Furnish Labor and Materials for Renovations to Oakland Hall LSUA
RFQ-000002778
LAGC Plan Room - North

DATE: May 18, 2026

Project: Renovations to Oakland Hall
Louisiana State University Alexandria
Architects' Project Number 2026.04

RE: Addendum Number Two (2)

DEMOLITION PLANS A2.0R

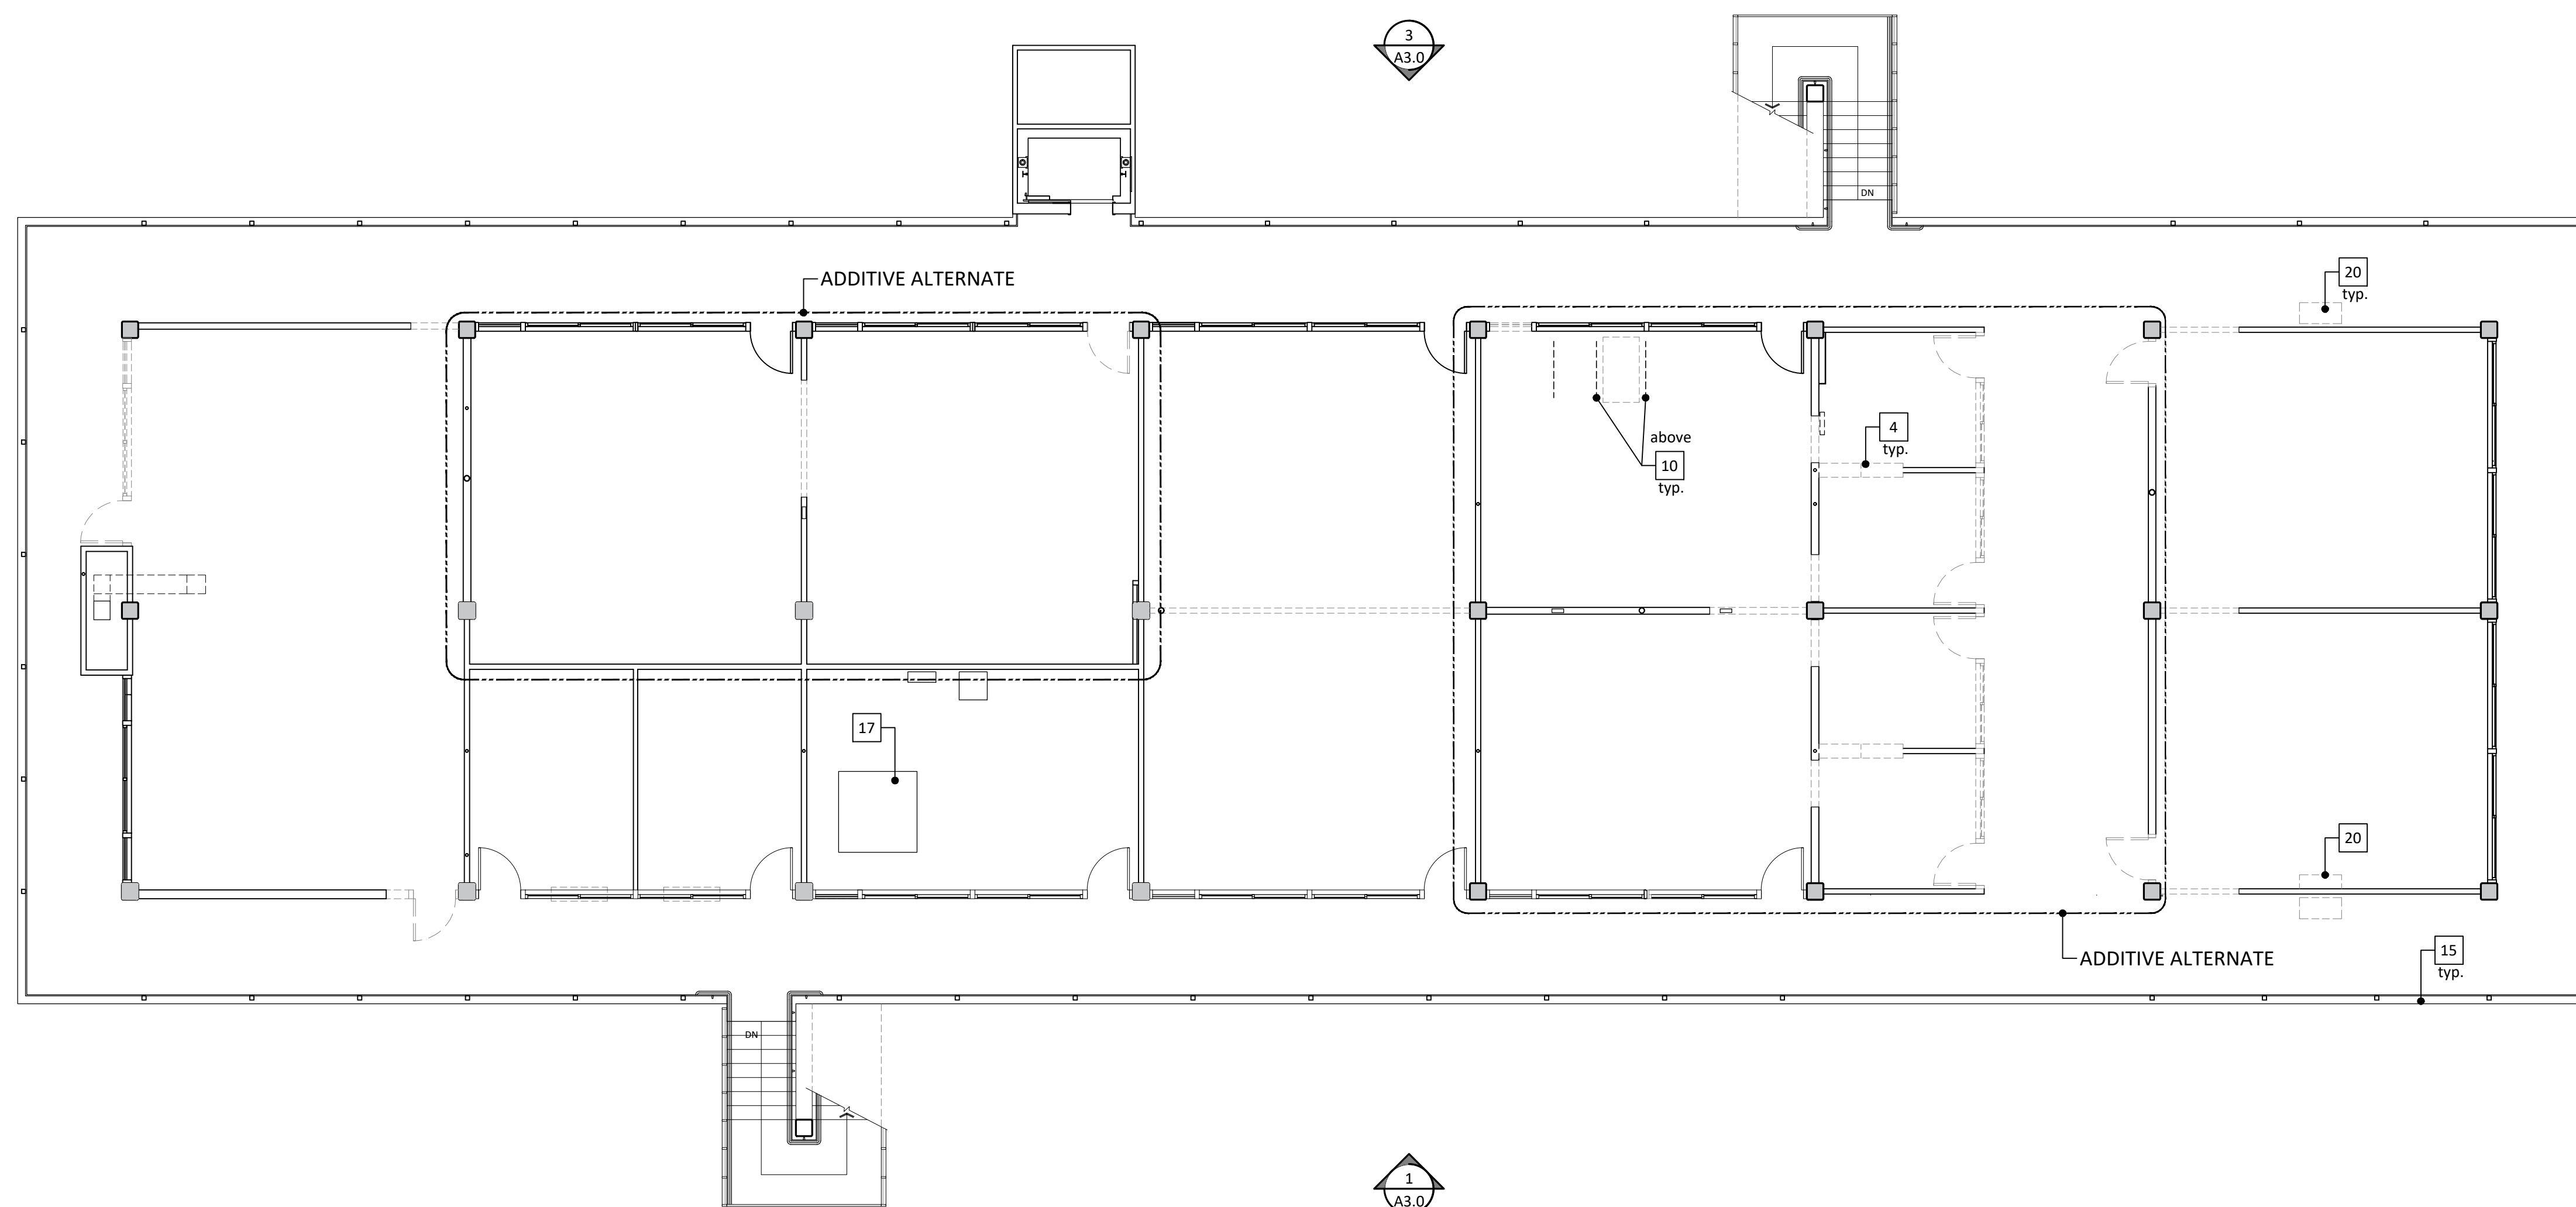
- k. Sheet P2.0:
 - 1. Delete new sink, SKC, and all associated piping, etc. in CLASSROOM 121.
2. Re: DRAWINGS:
- a. See revised Architectural sheets which accompany this addendum, which all contain the text for revision #2, general architectural revisions, 5.15.26, as follows:

- 1. A2.0
 - 2. A3.0
 - 3. A4.0
 - 4. A4.1
 - 5. A4.2
 - 6. A4.3
 - 7. A4.4
 - 8. A5.0
 - 9. A7.0
 - 10. A7.1
 - b. Sheet A7.2:
 - 1. Delete Details 1/A7.2 through 8/A7.2. Railing replacement is deleted from the project scope.
